Required Fan Shroud Modification for Proper Cooler Fitment

Ford MB3Z-8146-C fan shrouds require minor trimming to ensure proper fitment with the Garrett cooler. Failure to remove the highlighted material may prevent the shroud from seating correctly and can interfere with tab engagement.

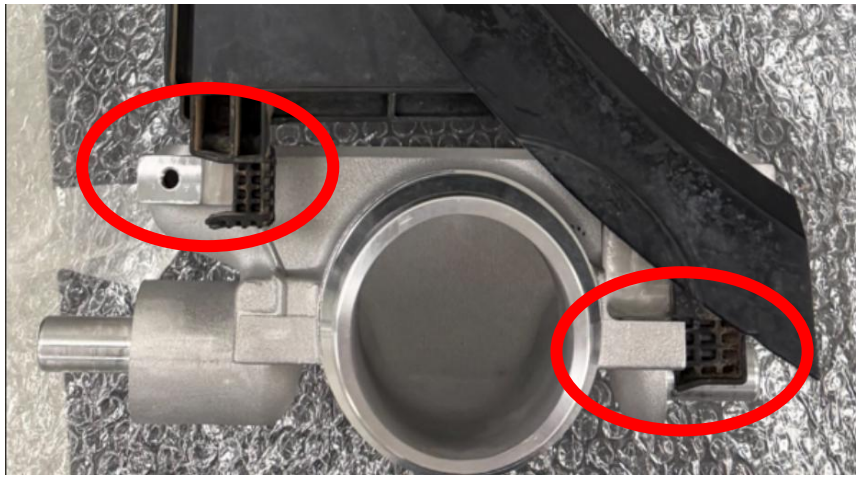
1. Modify the fan shroud as shown below.

2. Trim the shroud.

Remove the highlighted material from both ends of the shroud to provide the necessary clearance for proper installation of the Garrett cooler.

Using an appropriate cutting tool, carefully remove the marked sections of the shroud.

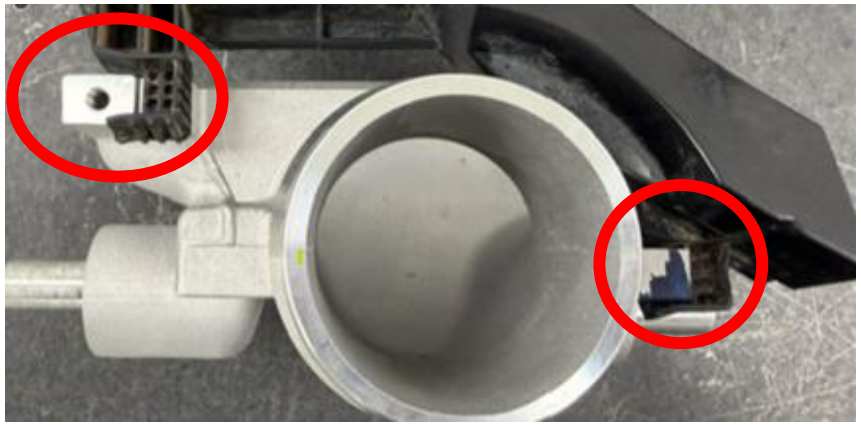
Before Trim:
Shroud does not seat properly on the cooler. Tabs cannot fully engage the slots.

After Trim
Shroud seats correctly on the cooler and tabs fully engage the slots.
